PAINT BRUSH HILLS FILING NO. 13E
CONSTRUCTION PLANS
KEY MAP WITH SIDEWALK LOCATIONS
INCLUDING TYPICAL ROAD SECTIONS

PAINT BRUSH HILLS FILING 13E
CONSTRUCTION PLANS
STREET IMPROVEMENT PLANS
KEATING DRIVE

PAINT BRUSH HILLS FILING NO. 13E CONSTRUCTION PLANS STORM SEWER PLAN

PAINT BRUSH HILLS FILING 13A
CONSTRUCTION PLANS
DETENTION FACILITY D
OUTLET BOX DETAILS

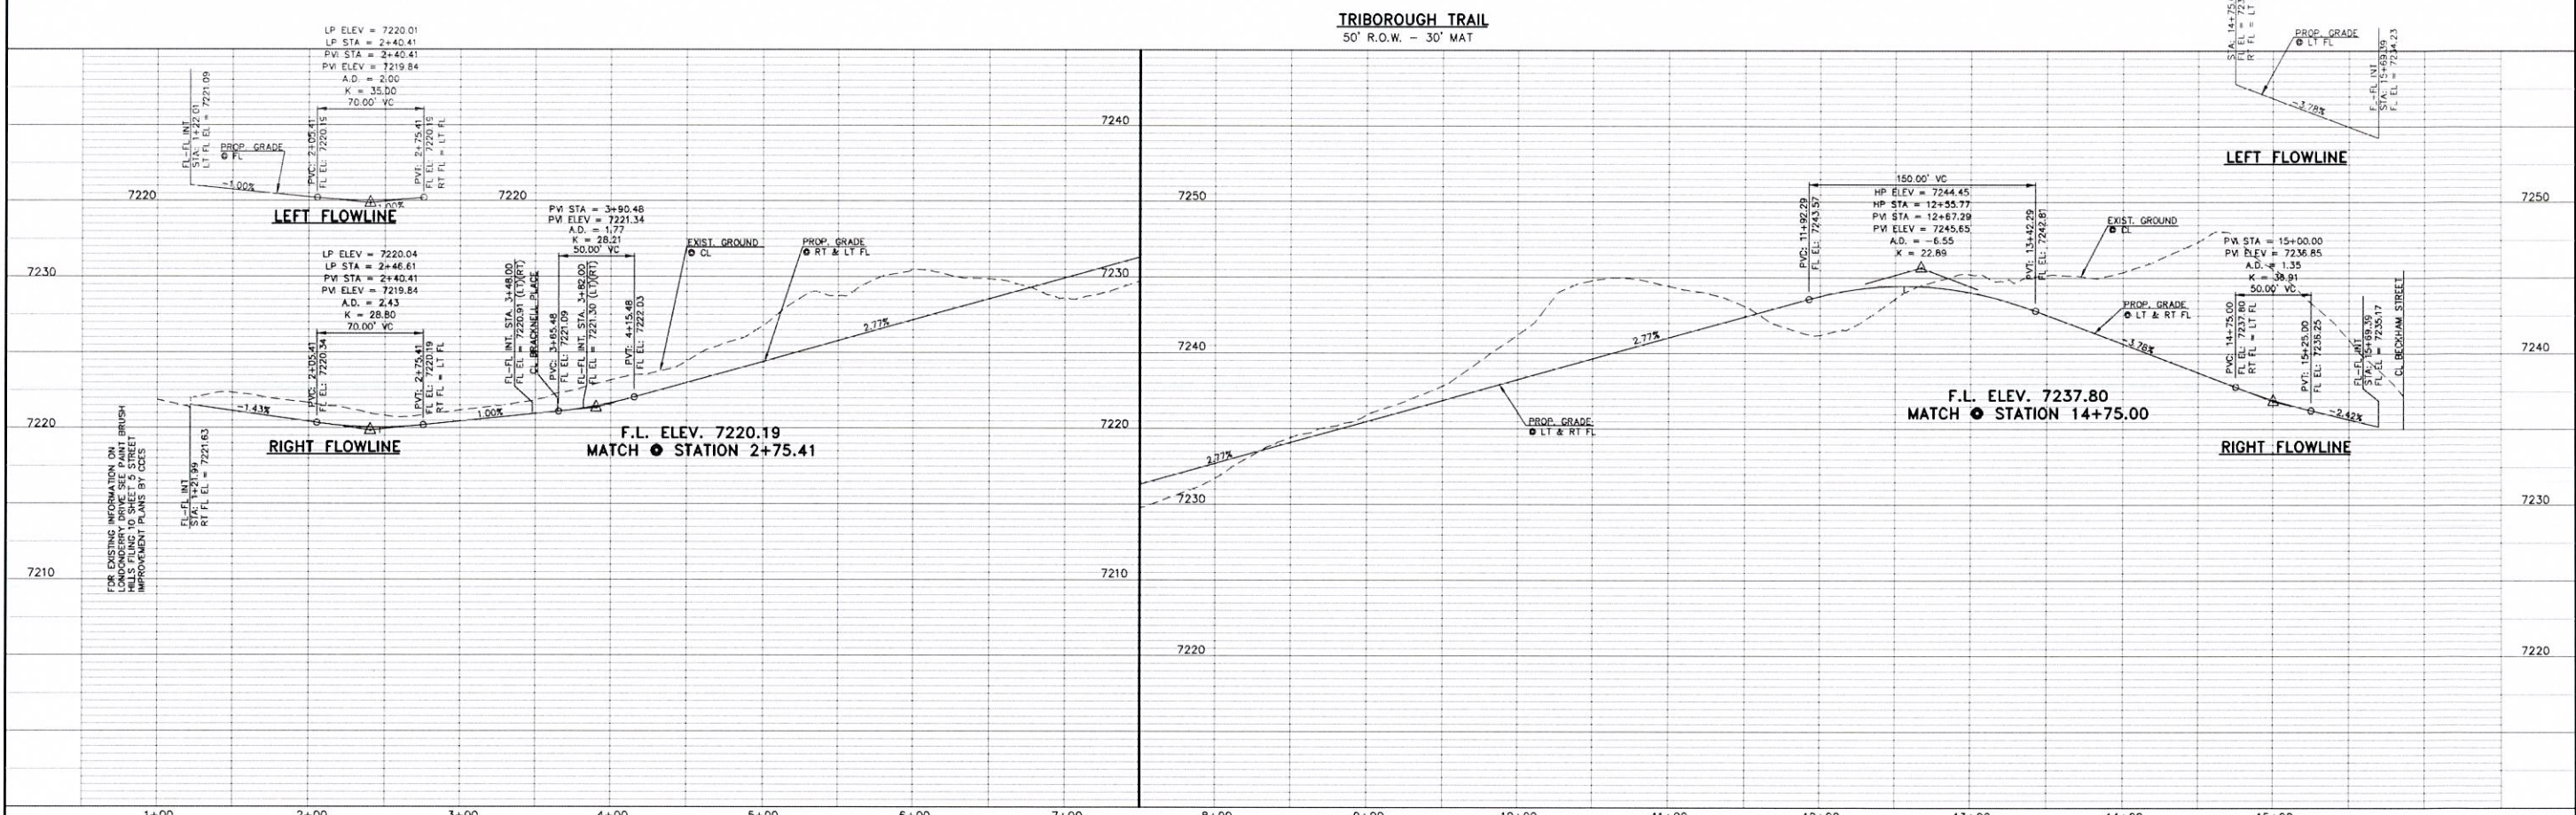
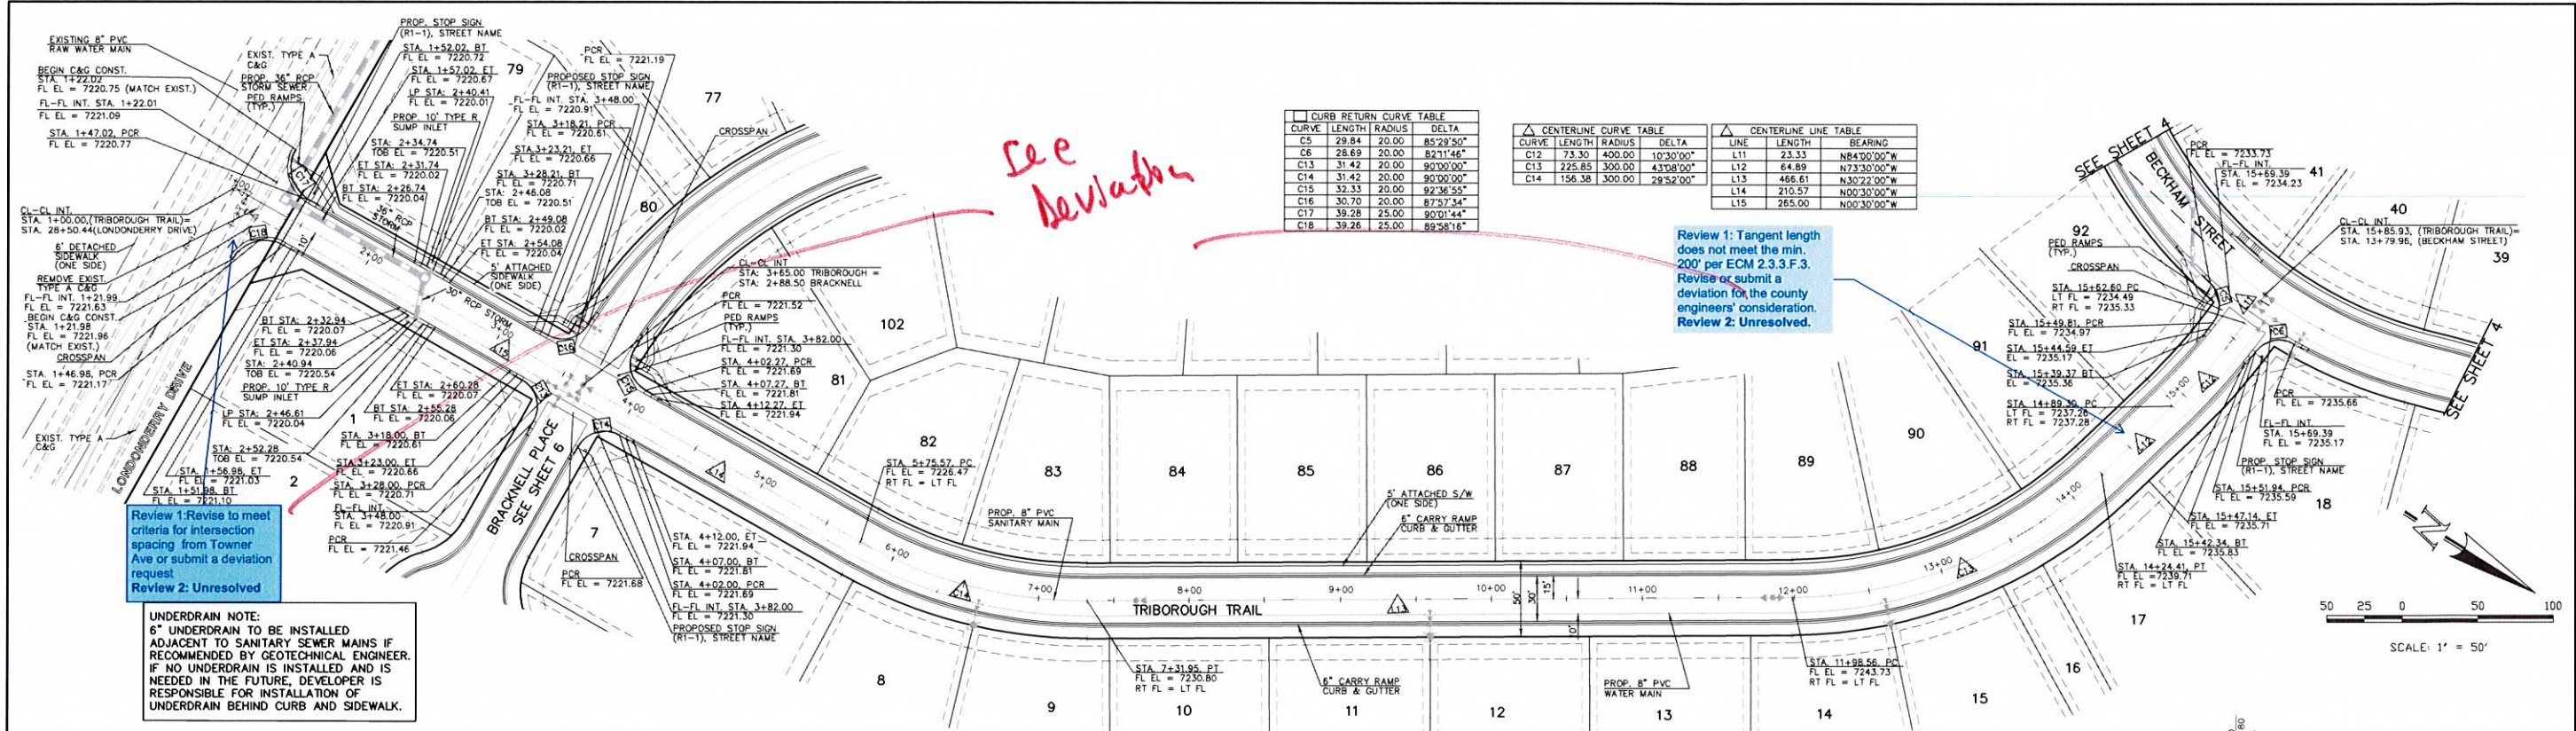
Per the Traffic Impact Study a south bound right-turn deceleration lane is required on Londonderry Drive approaching Rockingham Drive based on long term projection. This may be triggered with future PBH filings.

Include an exhibit with the Traffic impact study showing the anticipated reconfiguration of Londonderry Drive to verify if sufficient ROW is available for a southbound right turn deceleration lane. The plat may need to provide additional ROW for this future auxiliary lane.

Provide sidewalk along the north side of Londonderry Drive (highlighted in yellow) for an adequate pedestrian path to the schools. Per the TIS the only designated school pedestrian crossing is located at the Londonderry/Tower intersection.

Identify the specific type of curb & gutter (optional type C, type A, etc.) typical all road sections.

There seems to be a disconnect with the traffic impact study. The TIS notes all PBH Fil 13E internal streets should be classified as Urban Local.
Keating Road as a collector does not seem to connect to a similar or higher road classification.

*Londonderry is 80' ROW
with a paved width of 40'
right turn lane can be accommodated
with striping (similar to int. of
Londonderry and Tower)*

changed to local

Urban Residential Collector

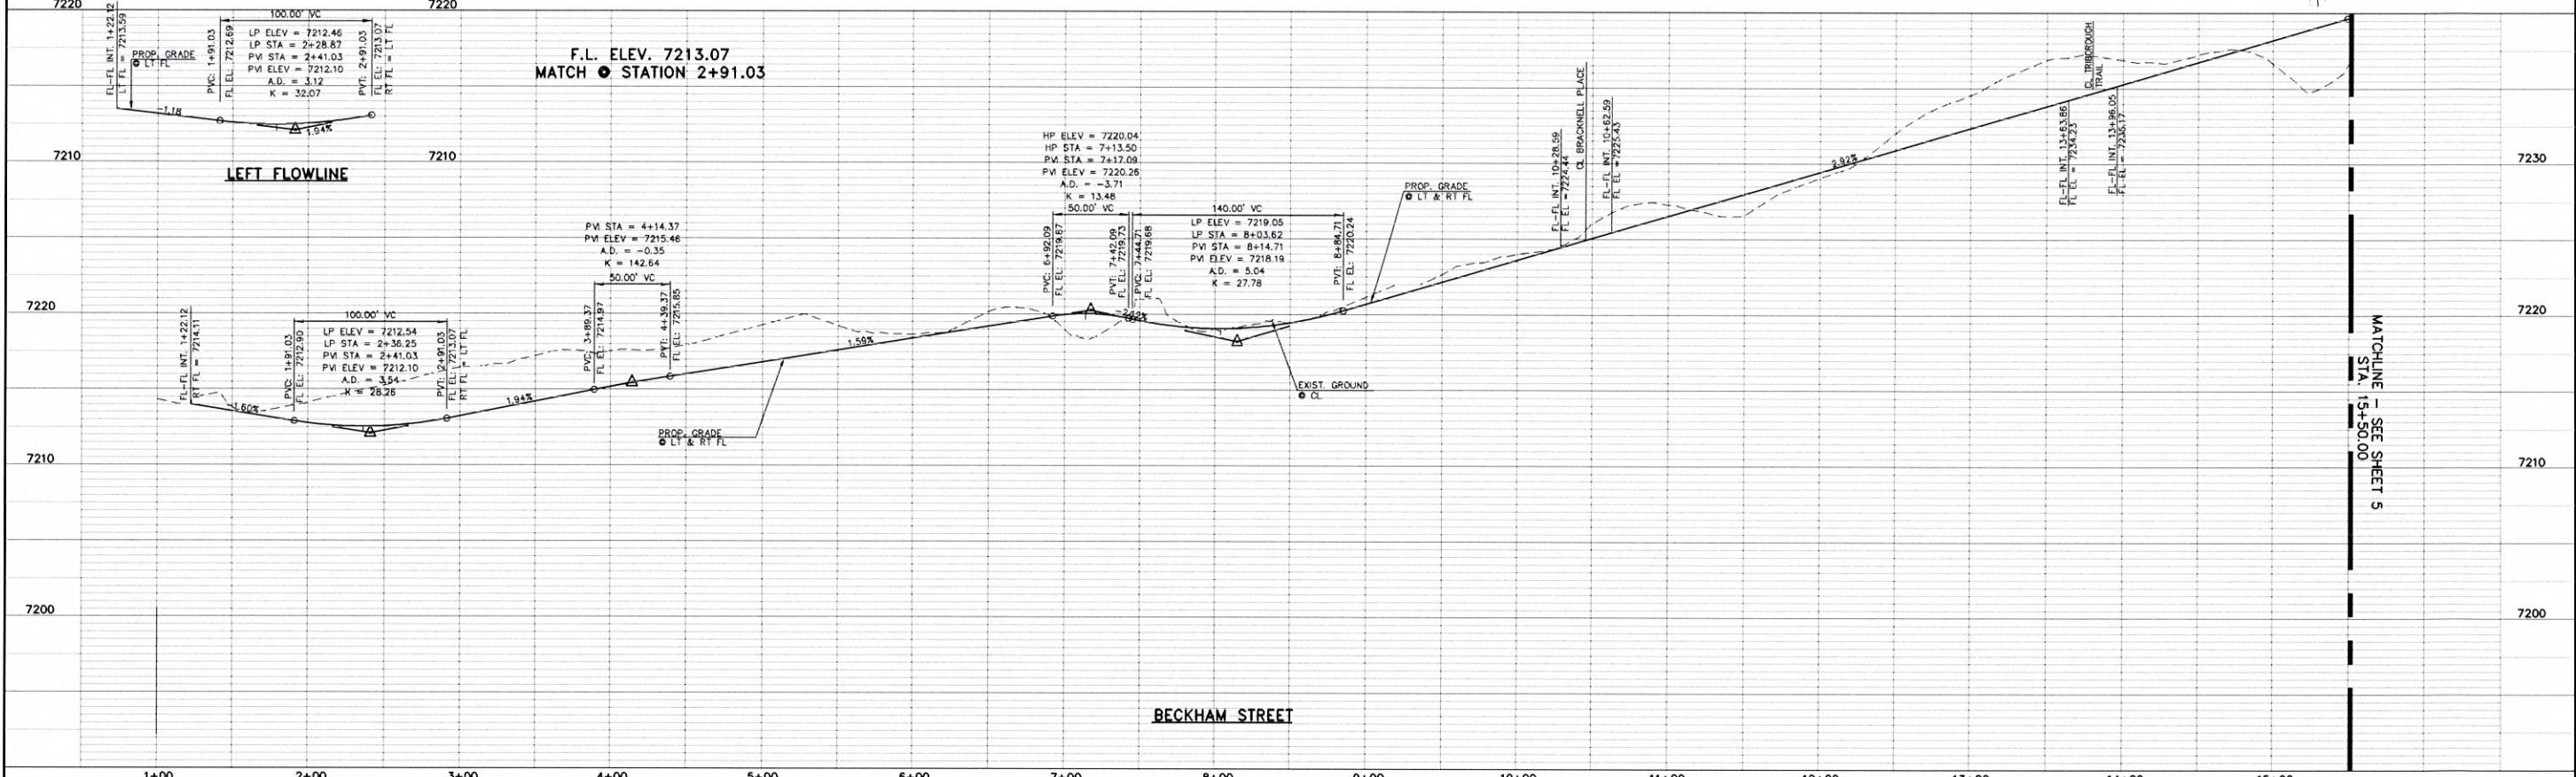
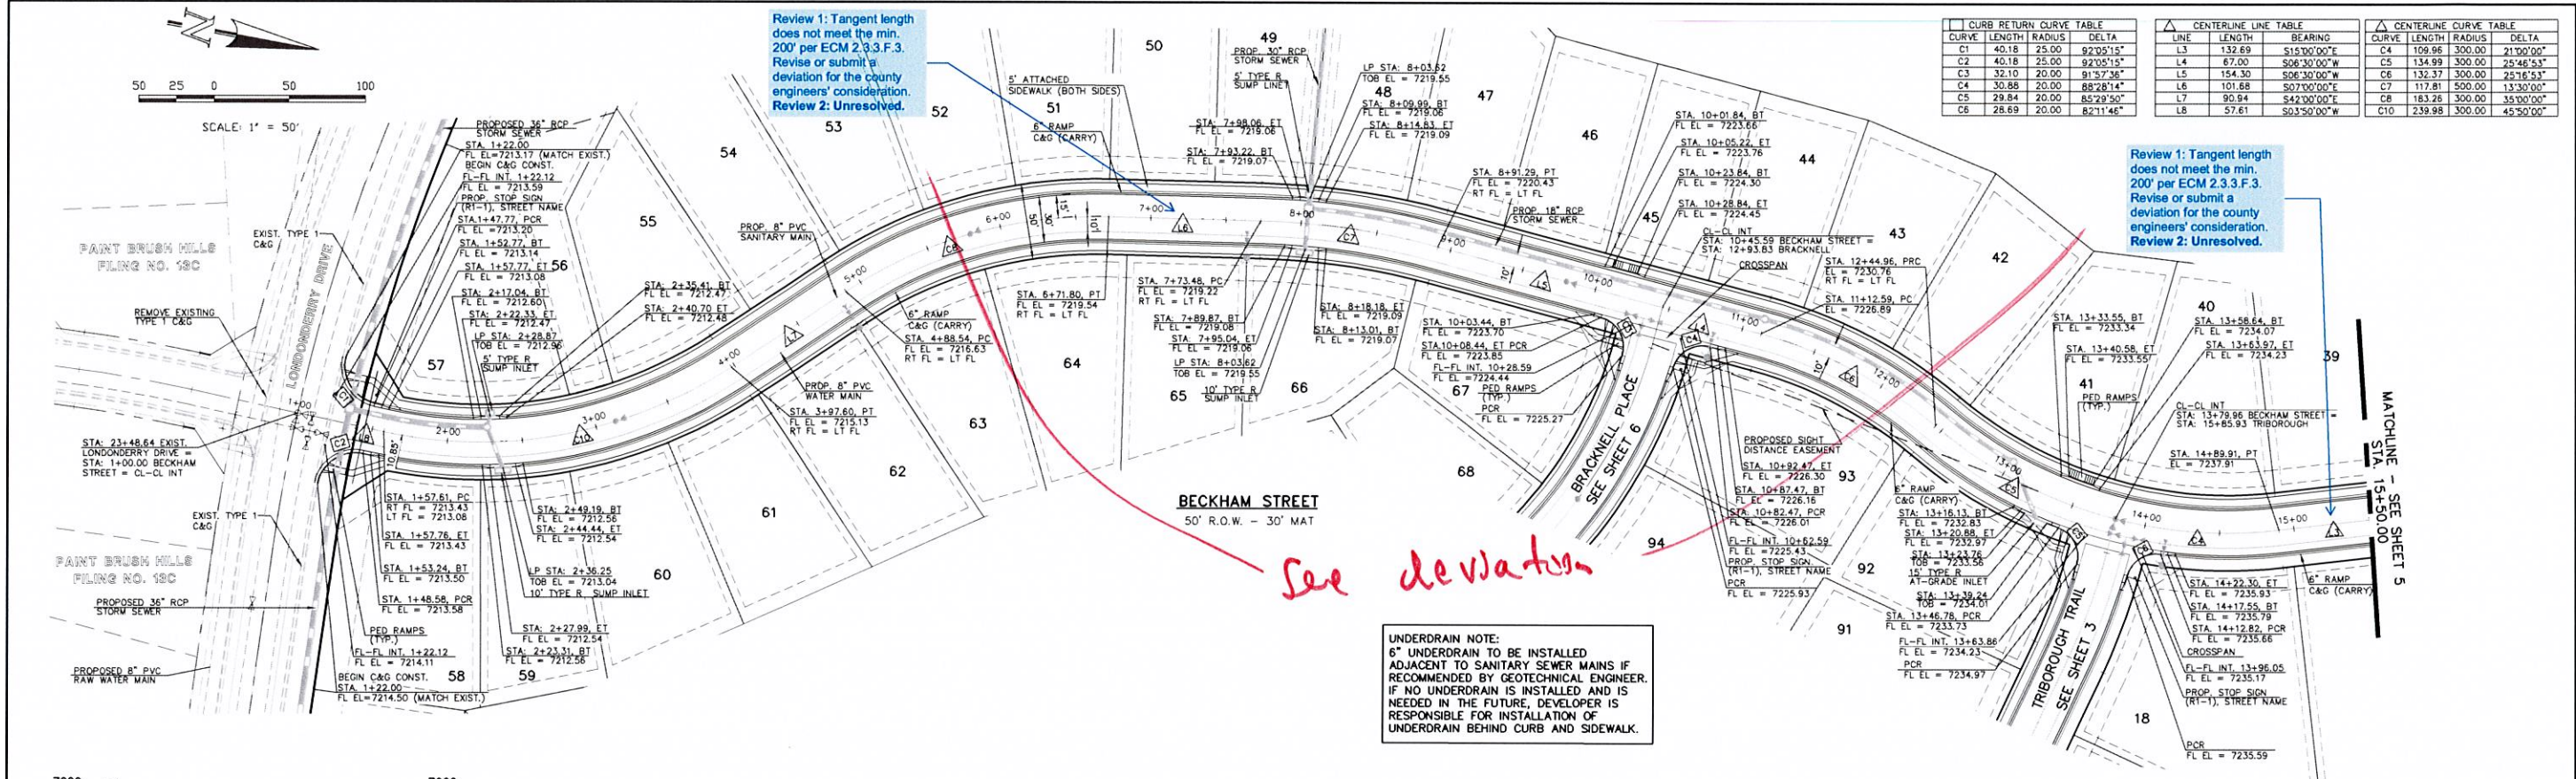
Review 1: Tangent length does not meet the min. 200' per ECM 2.3.3.F.3. Revise or submit a deviation for the county engineers' consideration.
Review 2: Unresolved.

Review 1: Tangent length does not meet the min. 200' per ECM 2.3.3.F.3. Revise or submit a deviation for the county engineers' consideration.
Review 2: Unresolved.

See deviation

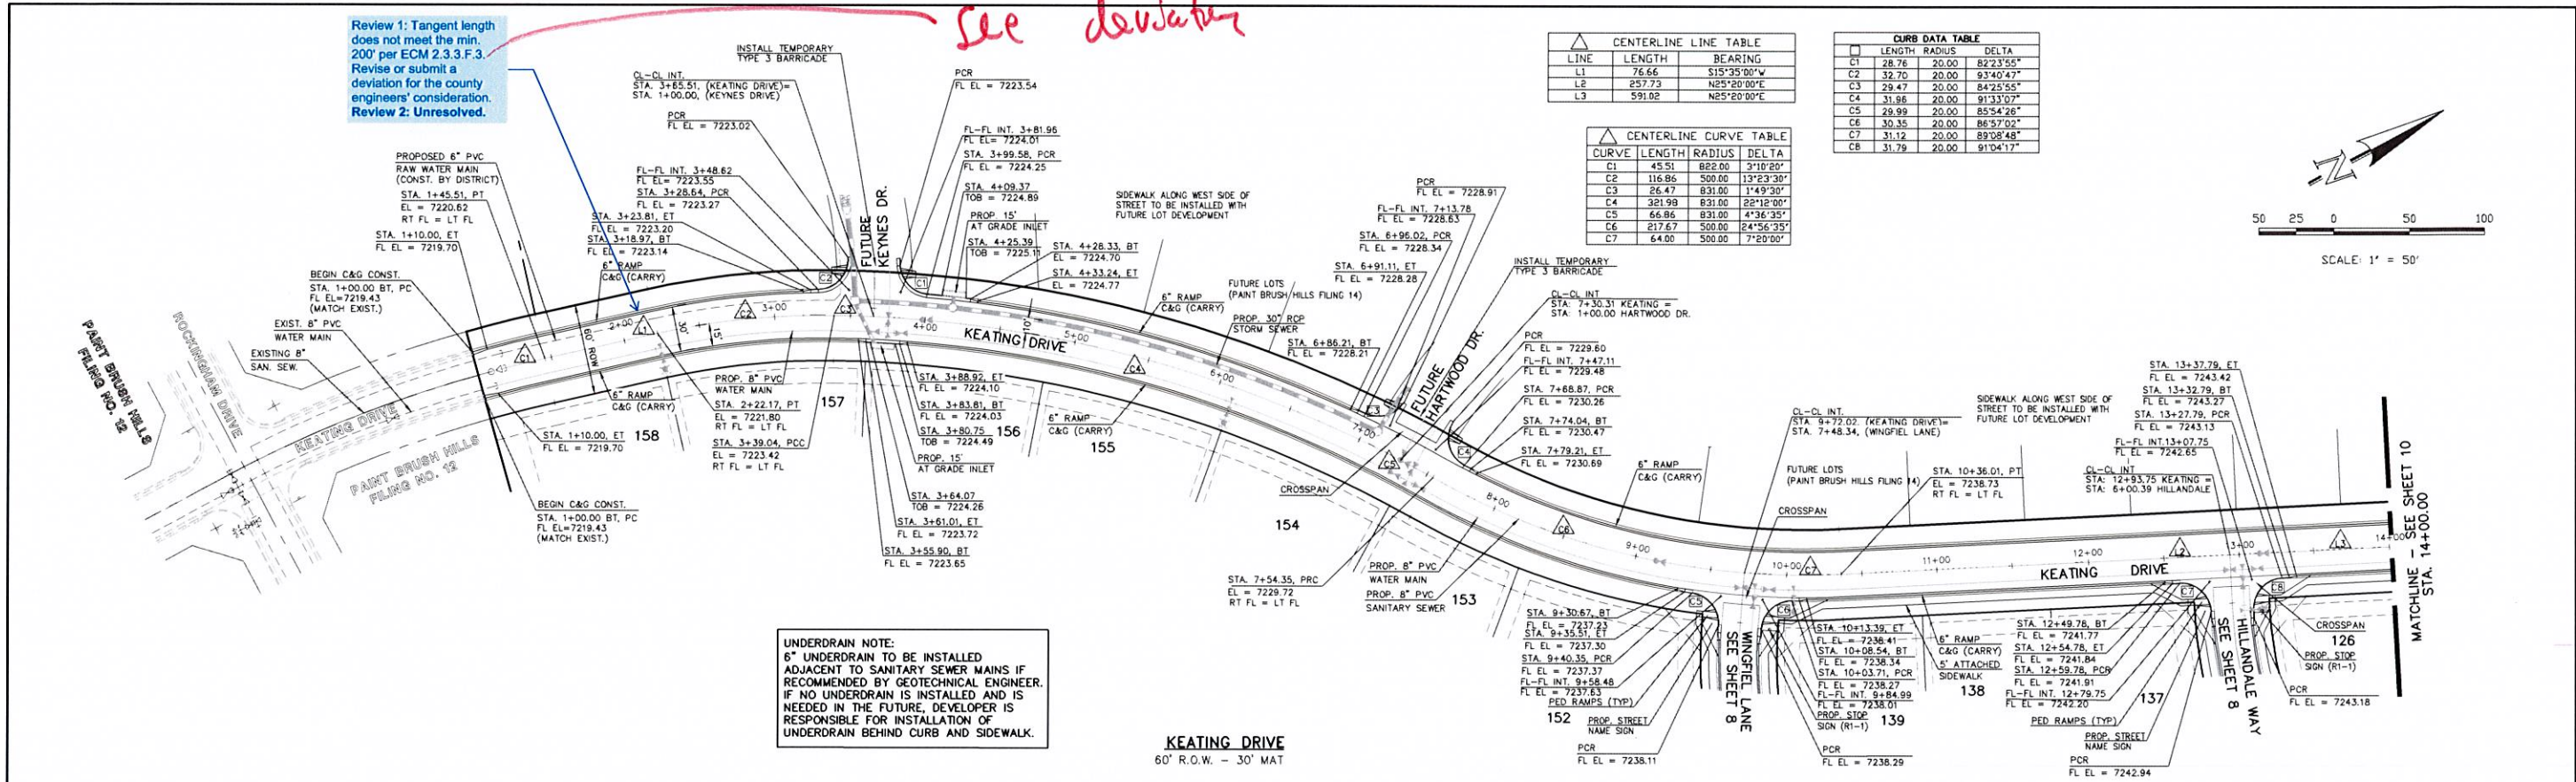
Review 1: Tangent length does not meet the min. 200' per ECM 2.3.3.F.3. Revise or submit a deviation for the county engineers' consideration.
Review 2: Unresolved.

See deviation
